ADDENDUM NO. 1

SEPTEMBER 17, 2024

- A. Project Name: BALL STATE HONORS HOUSE ADDITION
- B. Owner: Ball State University
- C. Owner Project Number: 2024-009.01 BA
- D. Architect: arcDESIGN
- E. Architect Project Number: 24118

E301

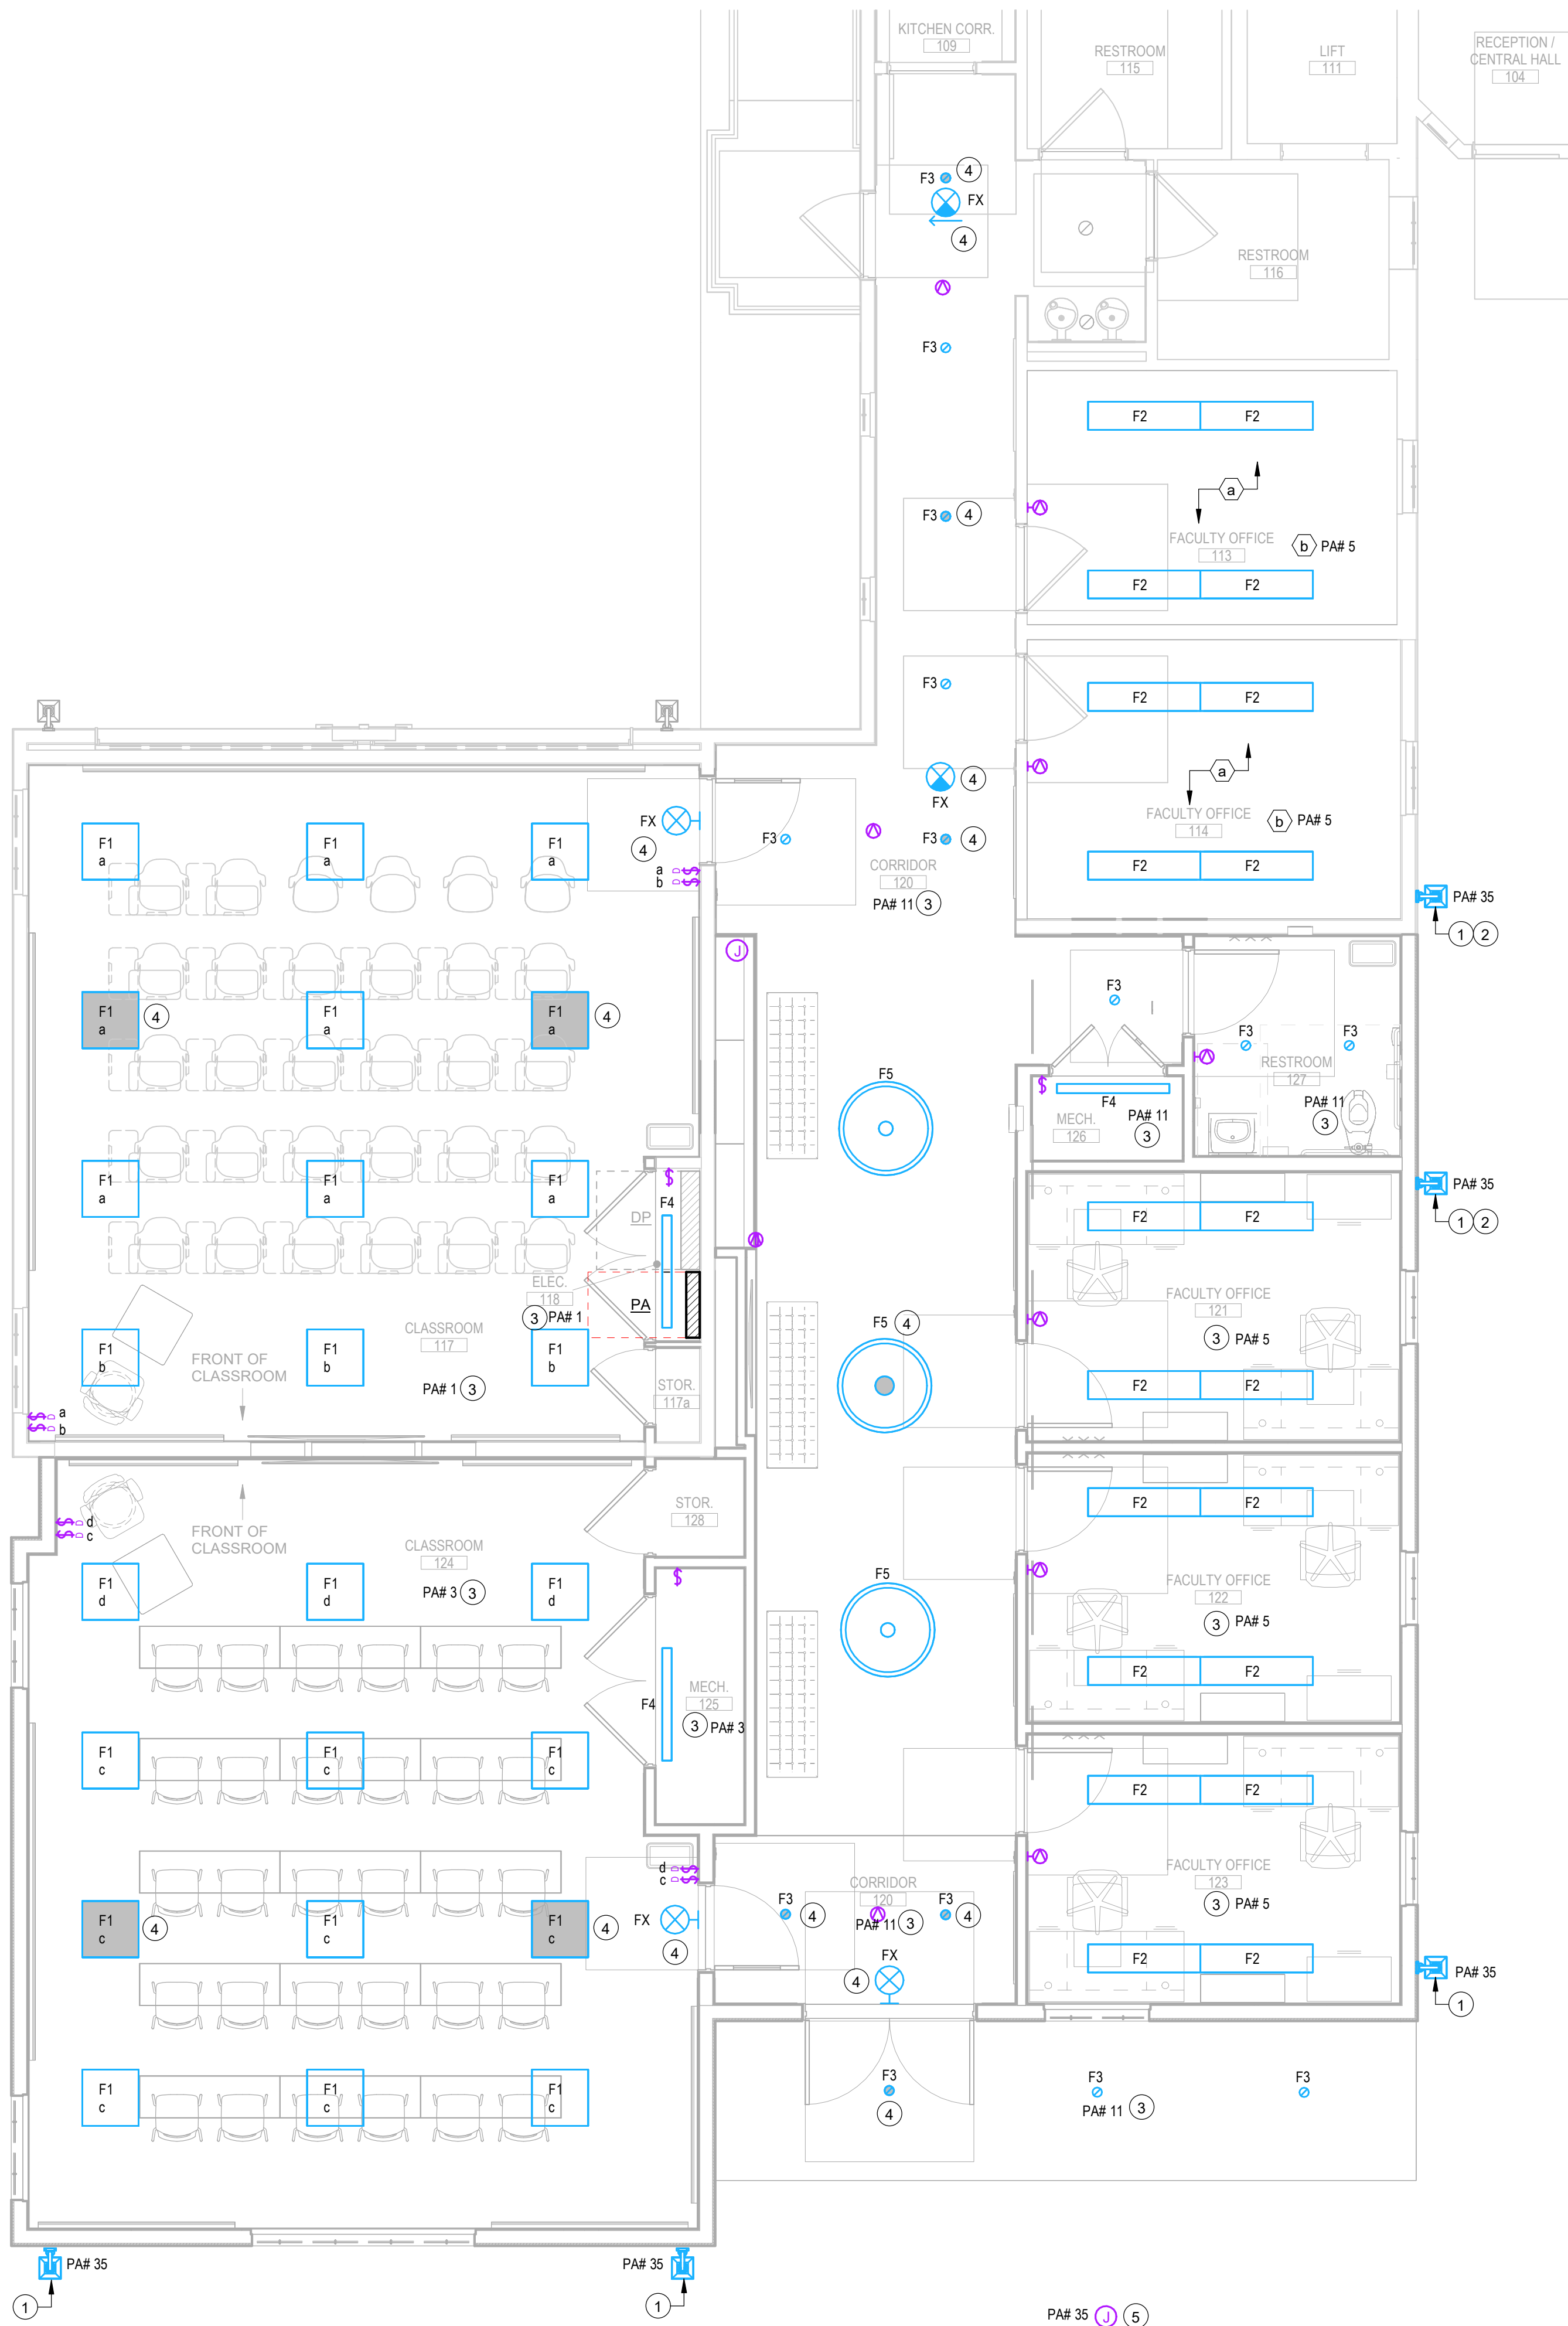
- 2. Revise notes on Basement Electrical New Plan as indicated in the attached revised Sheet.
 - G. Sheet E301 - FIRST FLOOR ELECTRICAL LIGHTING PLAN
 - 1. Revise Plan Note 1 as indicated in the attached revised Sheet.

- 2. Revise Plan Note 5 as indicated in the attached revised Sheet.
 - H. Sheet E302 - FIRST FLOOR ELECTRICAL POWER & SYSTEMS PLAN
 - 1. Add General Note D as indicated in the attached revised Sheet.

1. REINSTALL HISTORICAL DECORATIVE SCENCE AT NEW LOCATION. RECONNECT LIGHTS TO LIGHTING CONTRACTOR IN THE BASEMENT. REFER TO SHEET E100 AND E300 FOR LOCATION. PROVIDE NEW EDISON STYLE A26 BULB IN FIXTURE. SUBMIT CUTSHEET FOR BULB TO ARCHITECTS, ENGINEER AND LANDSCAPE BEFORE PURCHASE.

5. CONNECT 3 LIGHT POLES ALONG PATHWAY TO SAME CIRCUIT AS EXTERIOR SCENCE LIGHTS. REFER TO LANDSCAPING PLAN FOR LIGHT POLE LOCATIONS. CONNECT LIGHT POLES TO LIGHTING CONTRACTOR IN BASEMENT.

E302

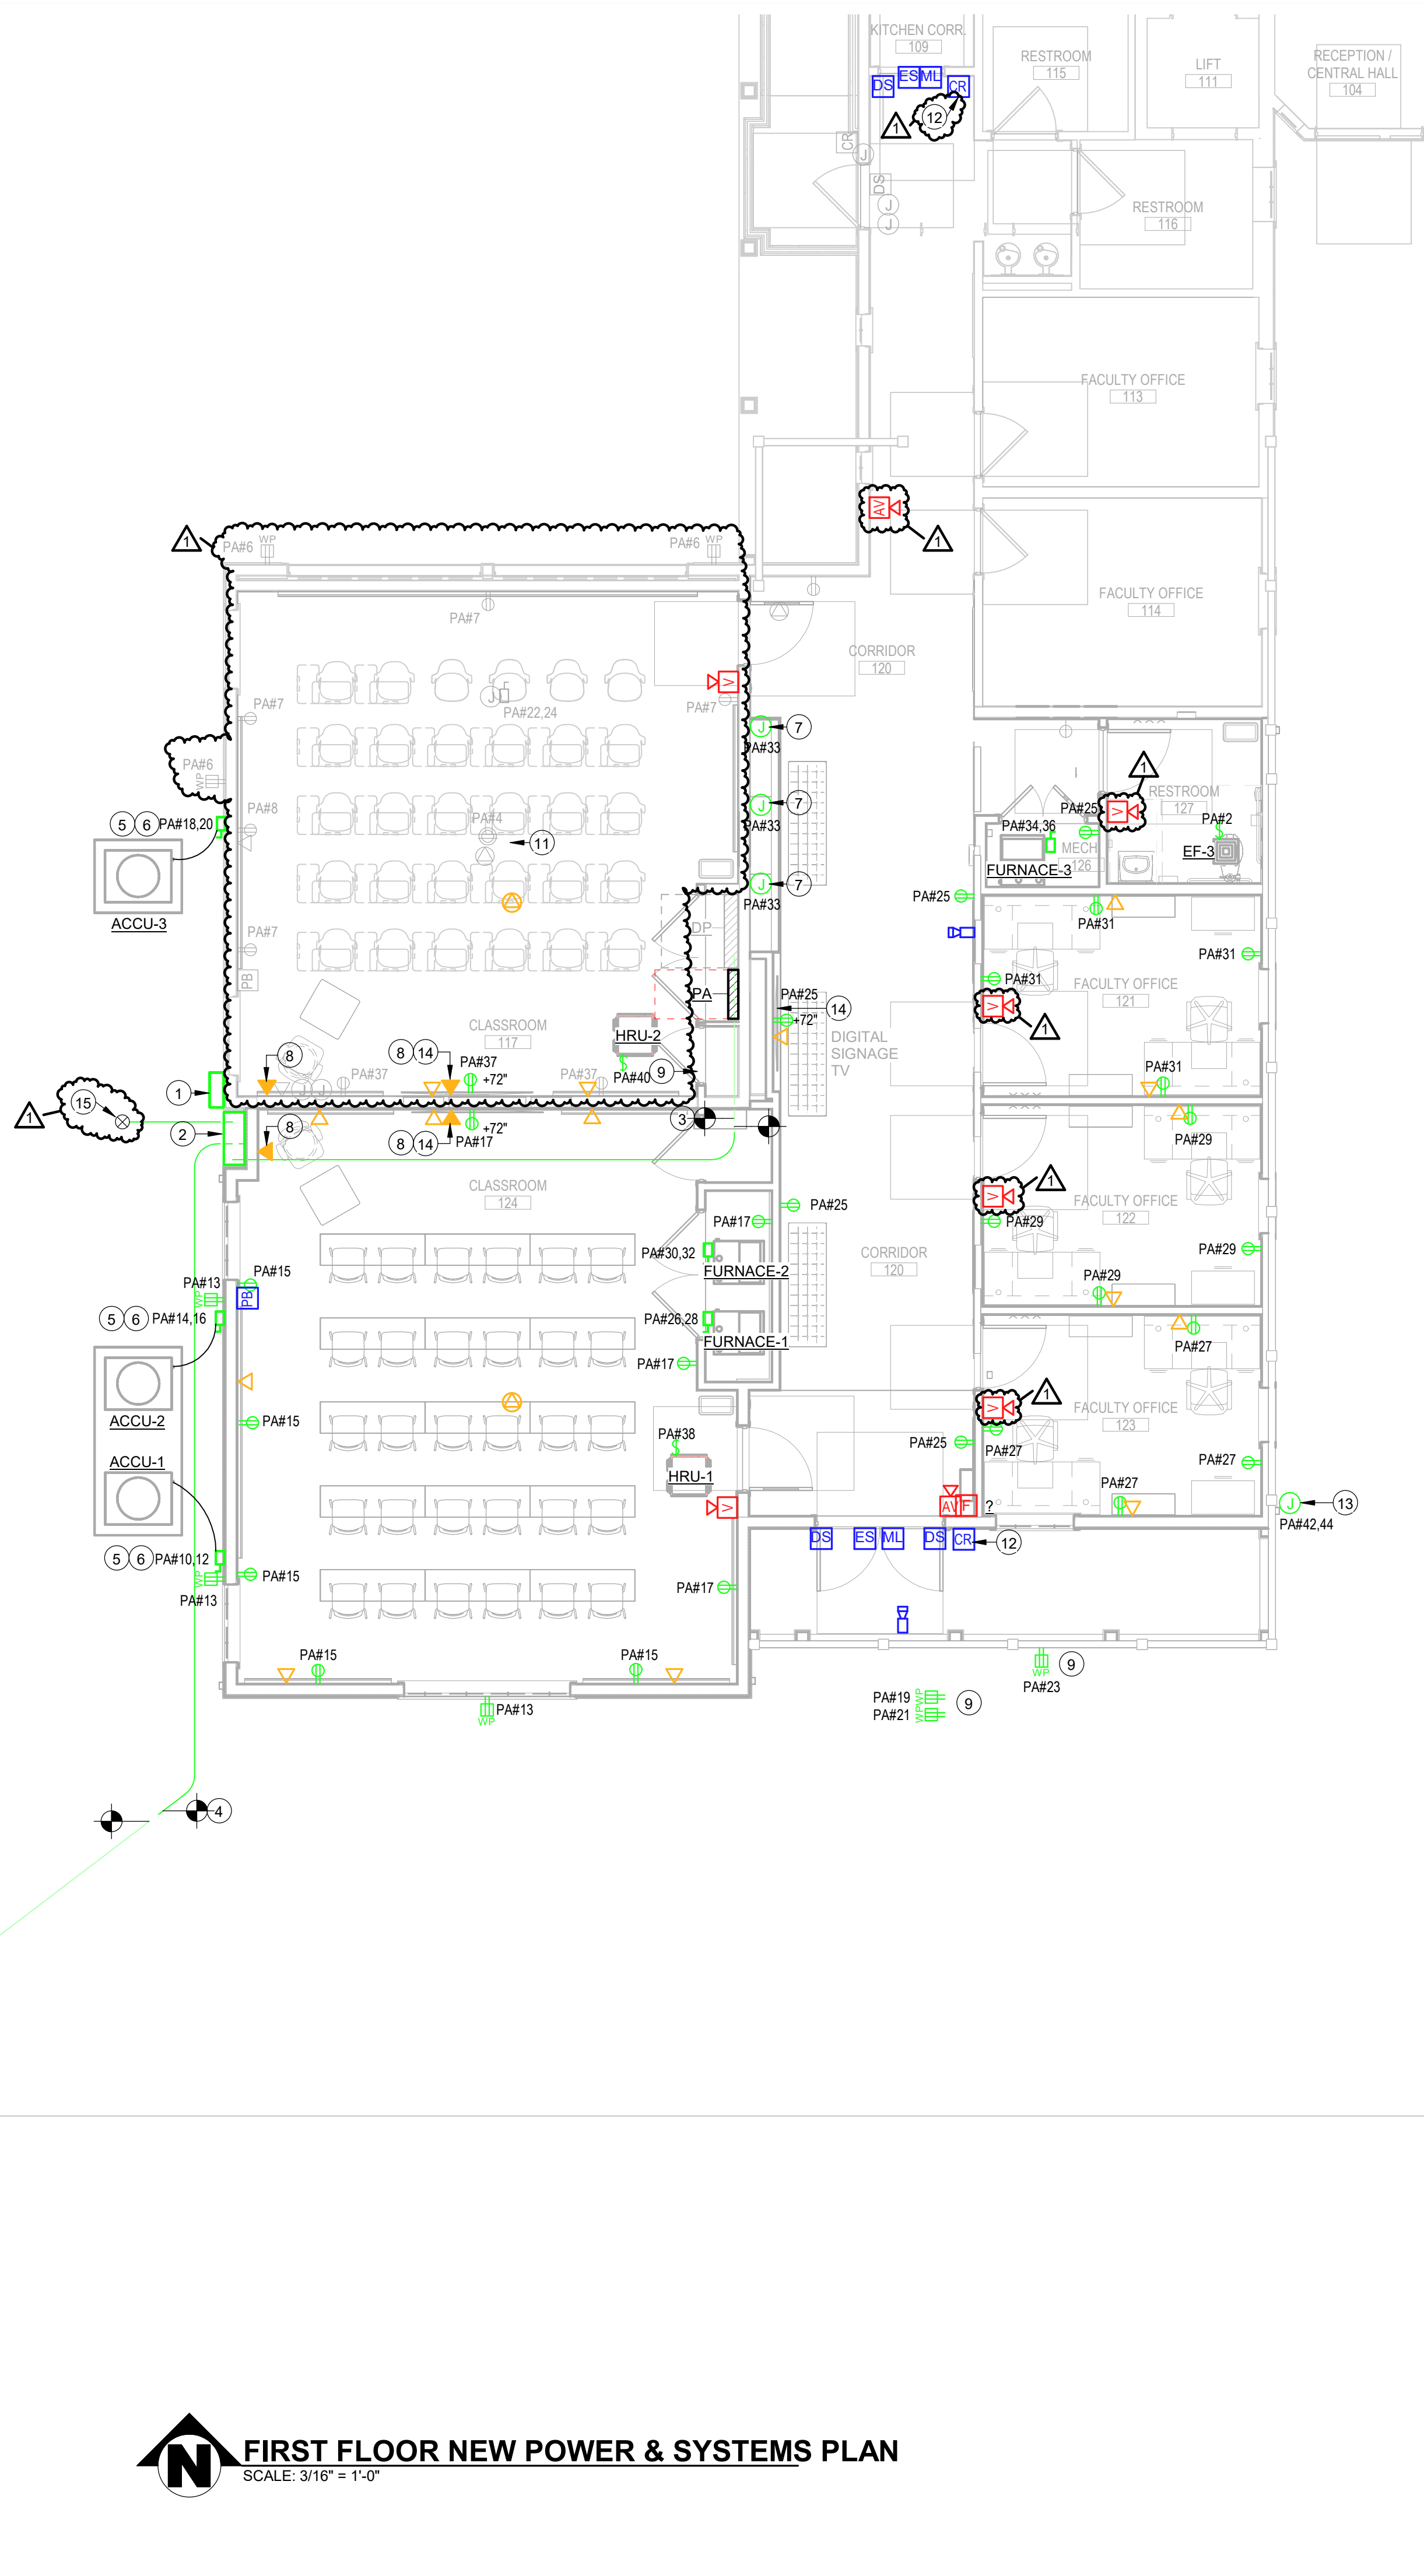
- 2. Revise Plan Note 13 as indicated in the attached revised Sheet.
 - 3. Add Plan Note 15 as indicated in the attached revised Sheet.
 - 4. Revise notes on First Floor New Power & Systems Plan as indicated in the attached revised Sheet.

- REFER TO SHEET E001 FOR GENERAL NOTES, SYMBOLS AND ABBREVIATIONS.
- COORDINATE NEW CONNECTION SWITCH-OVER WITH OWNER PRIOR TO PERFORMING WORK.
- NEW DATA WIRING TO BE CAT6, ROUTED TO DATA RACK IN BASEMENT. REFER TO SHEET E100 OR E300 FOR LOCATION INFORMATION.
- REFER TO SHEET E102 FOR EXISTING CONDUIT #S.

- PRIOR TO REMOVAL OF OLD METER BASE, INSTALL NEW METER BASE AT NEW METERING LOCATION. COORDINATE WITH AEP FOR CORRECT METER BASE TO INSTALL. METER ITSELF TO BE INSTALLED BY AEP.

- PROVIDE NEW CT CABINET WITH NEW BUILDING GROUND BUS BAR. CONNECT TO GROUND BUS IN DP PRIOR TO REMOVAL OF OLD BUS BAR.
- INTERCEPT OLD CONDUIT FROM CT CABINET TO DP. CONNECT TO NEW CT CABINET LOCATION. (2) PARALLEL SETS OF (3) #350 KCMIL & #1 GND. 2-1/2" C.

- INTERCEPT OLD CONDUIT FROM TRANSFORMER TO CT CABINET. PROVIDE NEW CONDUIT TO NEW METER LOCATION, 5" GRC. UTILITY TO PROVIDE WIRE.
- (2) #10 & #10 GND.

- PROVIDE 30A, HEAVY DUTY, NON-FUSED DISCONNECT. DISPLAY CASE CONNECTION FOR POWER AND LIGHTING.
- PROVIDE NEW 2" CONDUIT RACEWAY AND ROUGH-INS FOR A/V BETWEEN THESE TWO POINTS.

- REFER TO LANDSCAPING PLAN L600 FOR LOCATION OF RECEPTACLES IN STAIRS AND RAMP.
- NOT USED
- NEW 2" CONDUIT ROUTED FROM MASTER AV CONTROLS TO PROJECTOR LOCATION.

- PROVIDE NEW CARD READER AT THIS LOCATION, AND ANOTHER AT THE FRONT DOOR.
- OUTDOOR RATED POWER UNICHOX FOR OUTDOOR A/V. PROVIDE NON-NEMA 250V 2-POLE 3-WIRE 50A PLUG. CS8269 WITH (3) #8'S AND #10 GND. 3/4" C. GRC.

- PROVIDE SINGLE GANG BOXES AND RACEWAY FOR POWER AND DATA IN ADDITION TO THE 2" RACEWAY FOR A/V. USE 1-1/2" RACEWAY FOR THE DATA, AND 1" FOR POWER CONNECTIONS.

- PROVIDE NEW GROUND ROD 3/4"x10" BURIED 18" BARE 4/0 COPPER BETWEEN BUILDING GROUND BUS AND NEW GROUND ROD.
